14/55-05A 9400 Huntmaster Rd
MP Site #14/55 Avalon Farm

SUBJECT: Historic Area Work Permit Application # 369778

SUBJECT: Historic Area Work Permit # 369778

The Montgomery County Historic Preservation Commission (HPC) has reviewed the attached application for a Historic Area Work Permit (HAWP). This application was **APPROVED with CONDITIONS**.

Front (north) elevation [proposed]

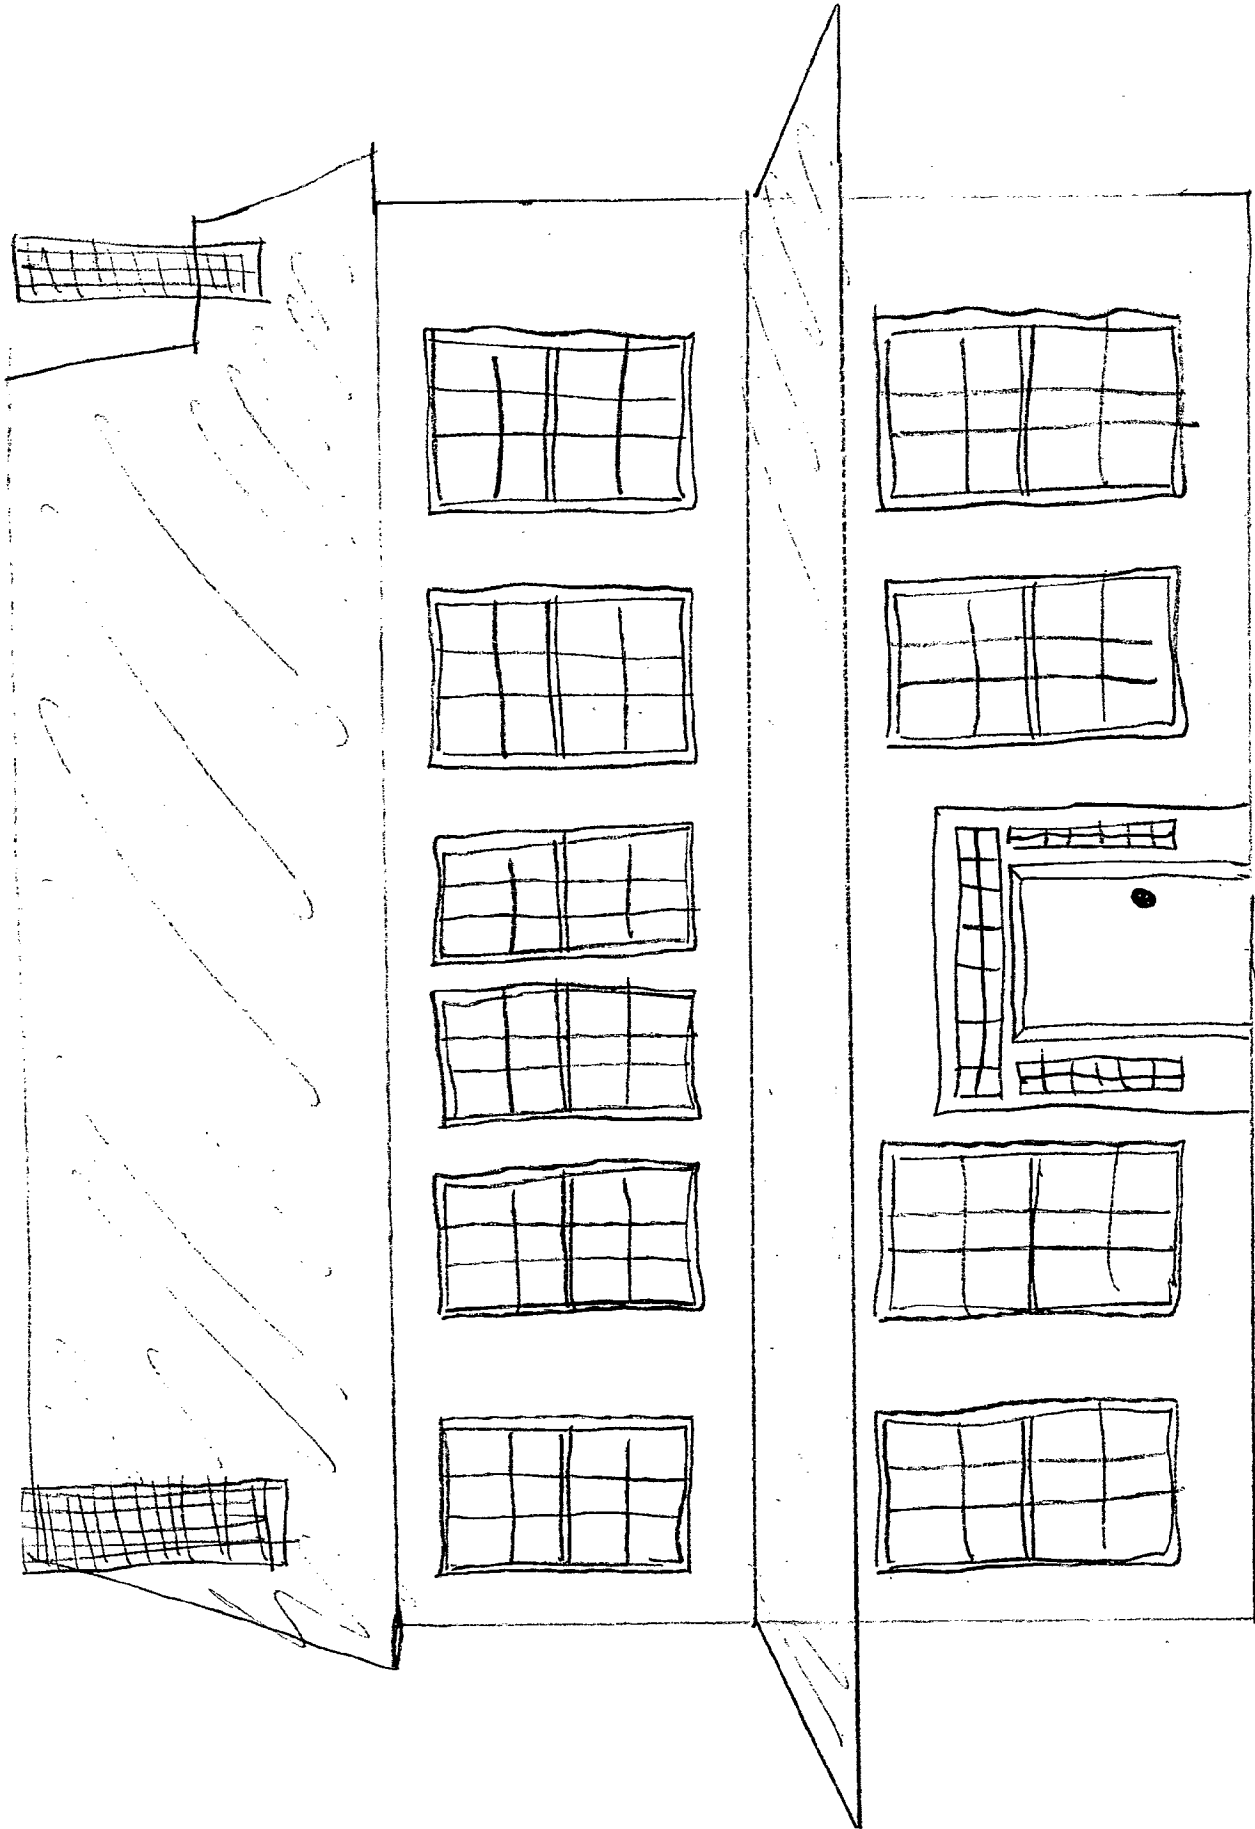
- 1) The new French door will not increase the width of the existing window opening.
- 2) The new set of three double-hung windows is replicated according to the historic blueprints. Specifically, the windows should be single pane with true divided lights in the exact configuration shown on the drawings.
- 3) The proposed windows will be repaired rather than replaced.
